SHEET		1		OF		1	
MESA TOPS AT RIDGEGATE		ENTRANCE ROAD ALT A — W/O WALLS					
JOB NO.		15950.12

MESA TOPS AT RIDGEGATE
ENTRANCE ROAD ALT B
WI WALLS

PRELIMINARY ROAD REDESIGN
ALTERNATIVE 1
MESA TOPS – CABELA DRIVE
1595018
10/28/2024
SHEET 1 OF 2

MESA TOPS AT RIDGEGATE
ENTRANCE ROAD ALT F
WI WALLS

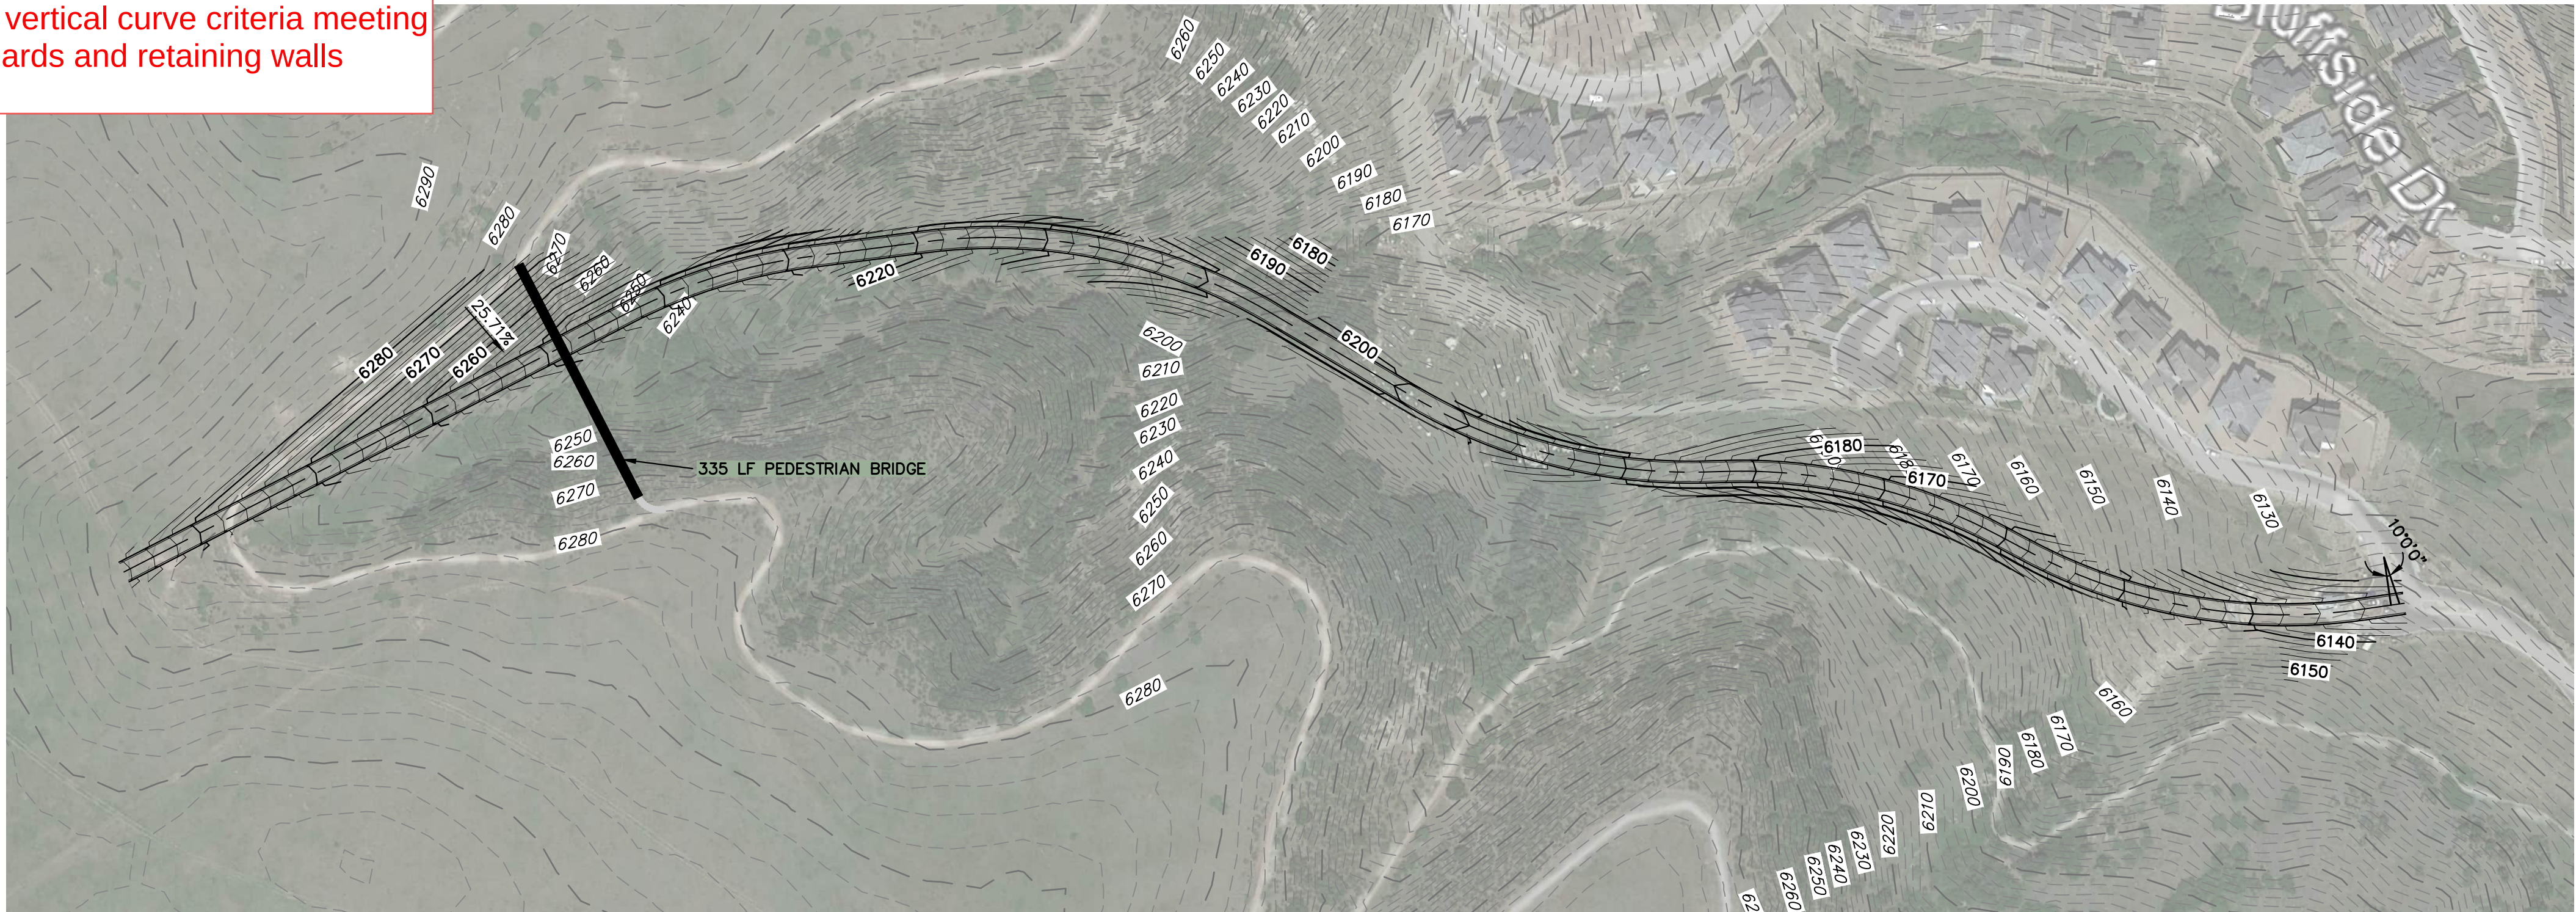
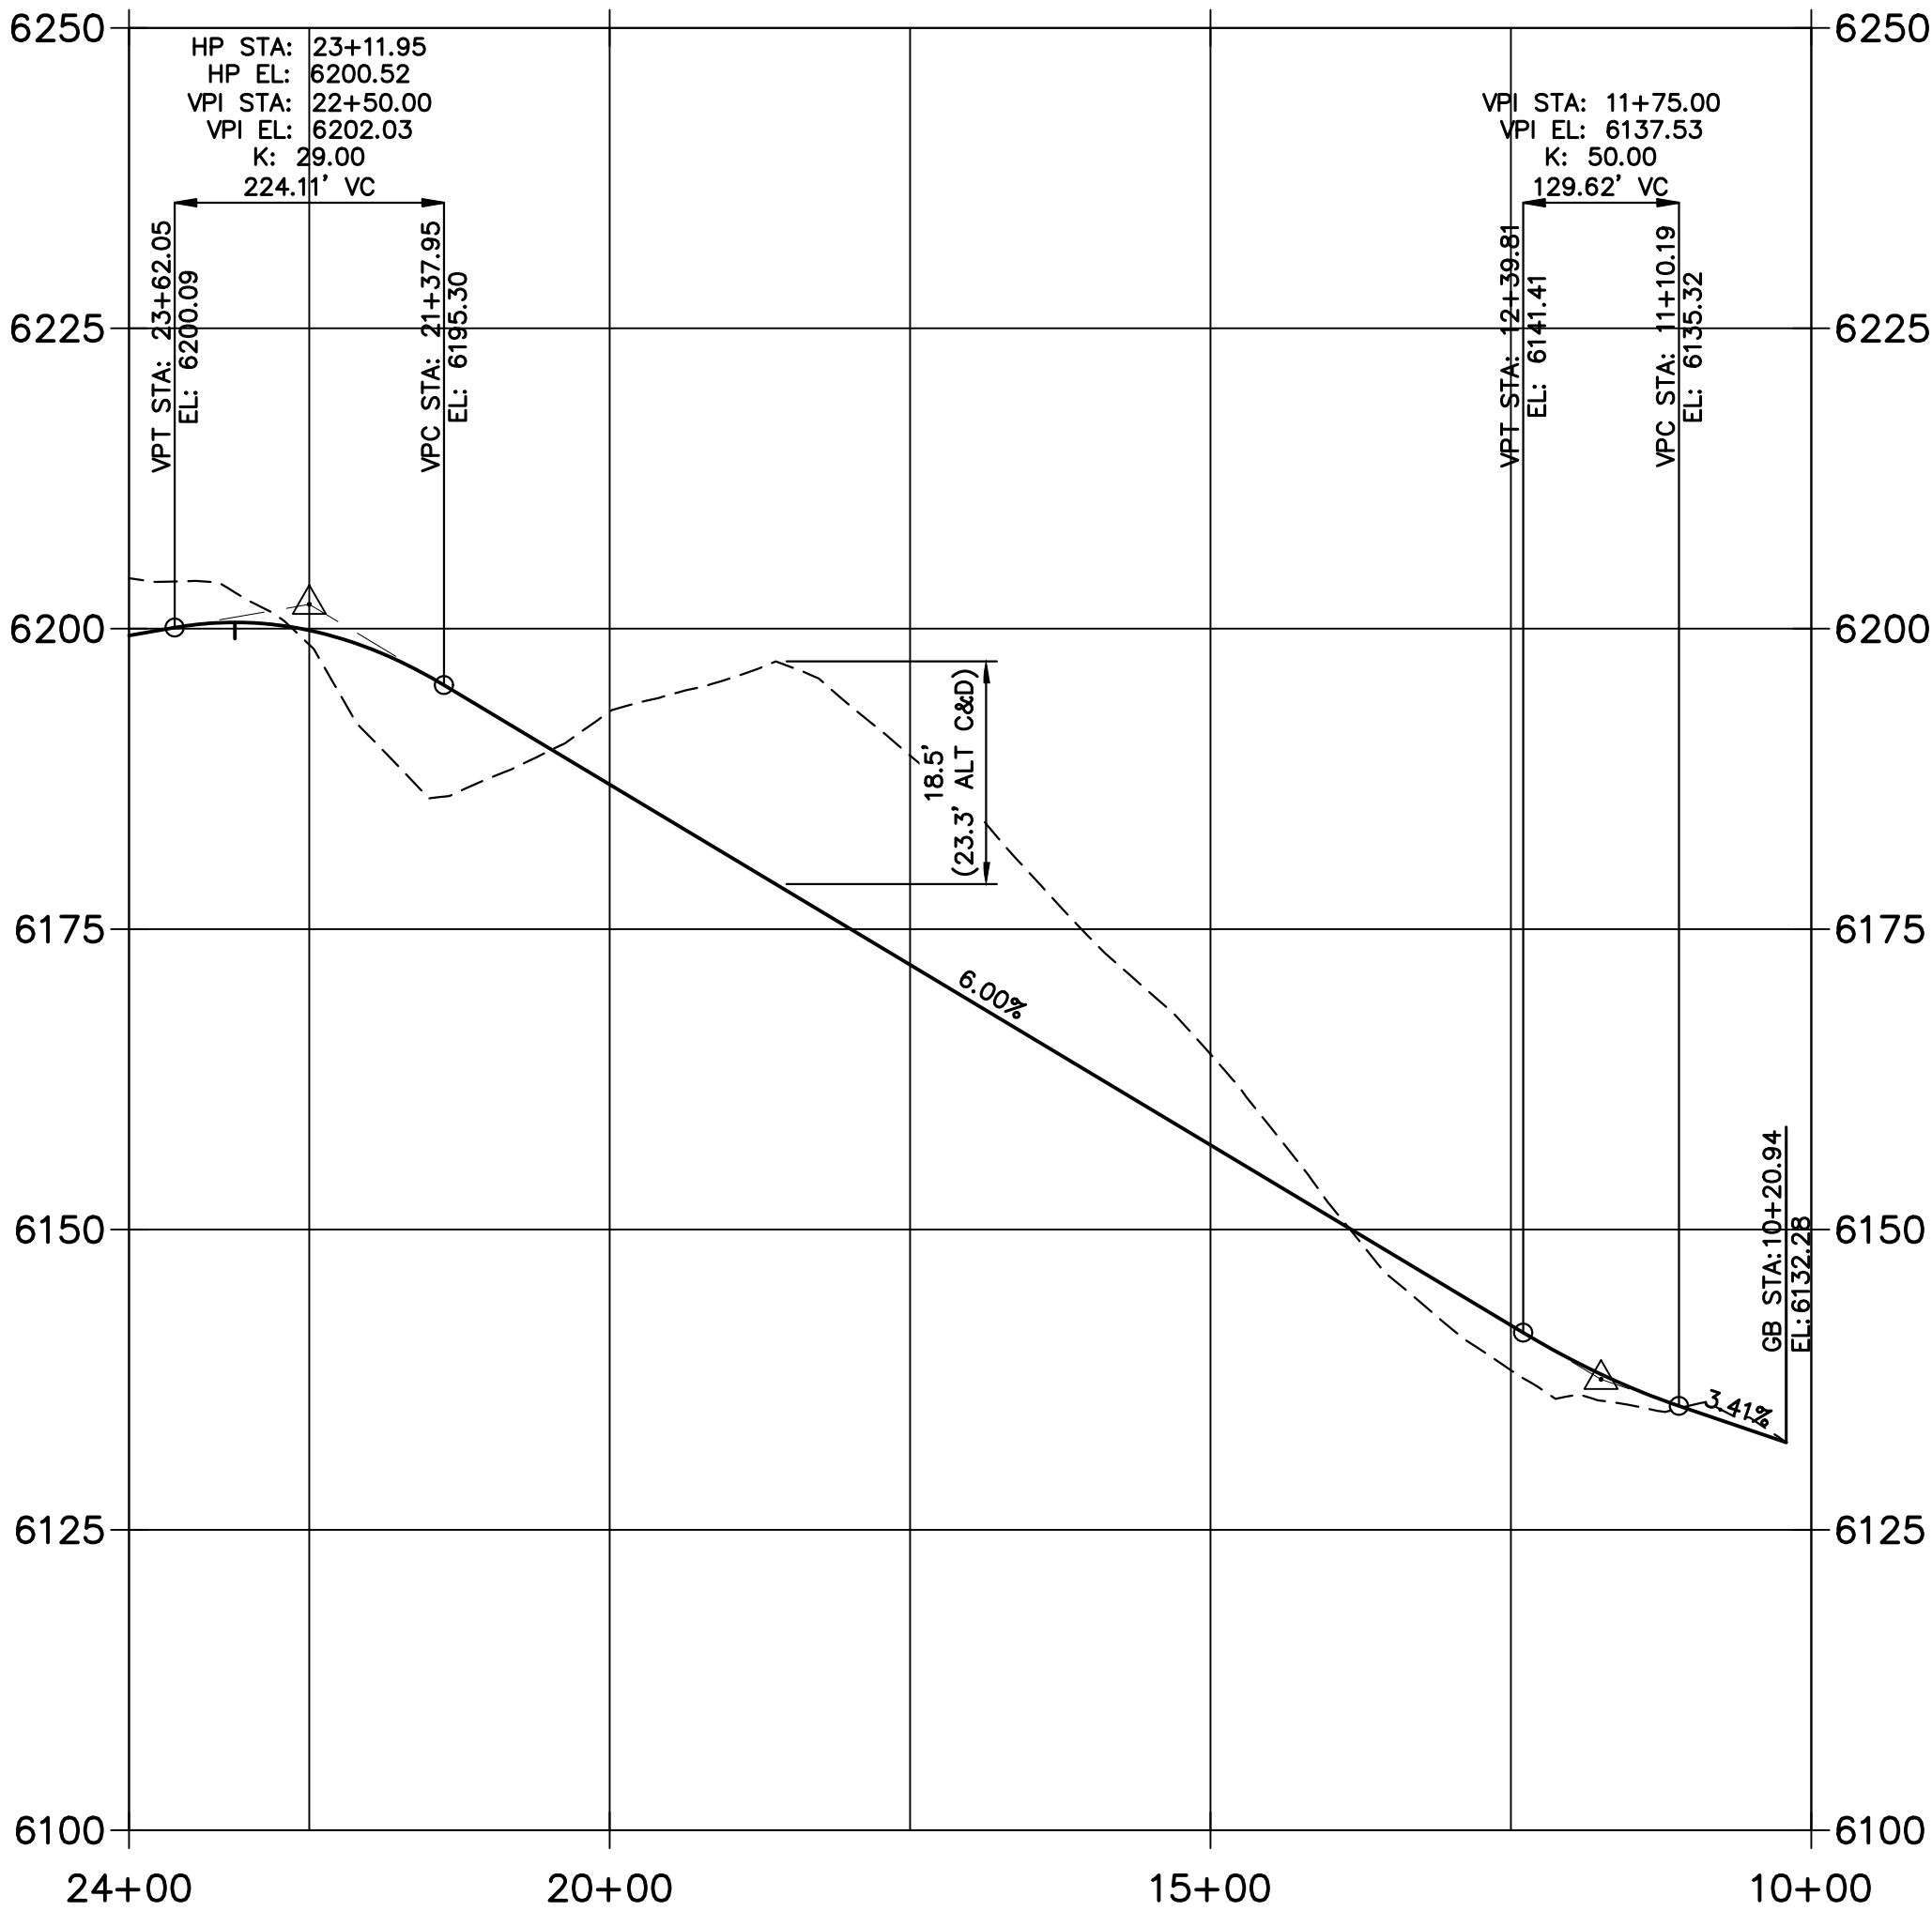
Option not selected -

- Typical section does not include sidewalk.
- Current alignment generally follows with horizontal and vertical curve criteria meeting collector standards and retaining walls revised.
